Re: Centrica Storage Limited's response to National Grid Gas's Consultation on the revised NTS Exit Capacity Release Methodology Statement (ExCR v7.1)

Annex 1 – Working Example (Mod 417) on the “14 months notice” rule

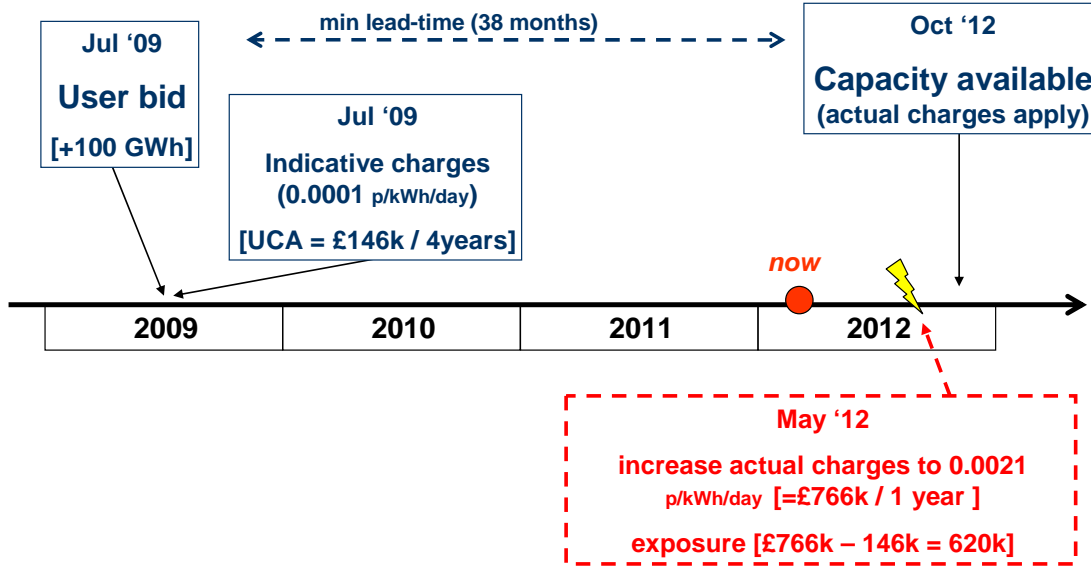
It is proposed to amend the “14 months notice rule” such that affected Users are allowed to make an application during the Reduction Application Window preceding the first day of registered capacity for a reduction with effect from the 1st of any month after the UC has been satisfied. NGG will reject such application only if the UC will not be satisfied by the requested reduction date, given the actual charges⁴.

See annex 1 for a working example.
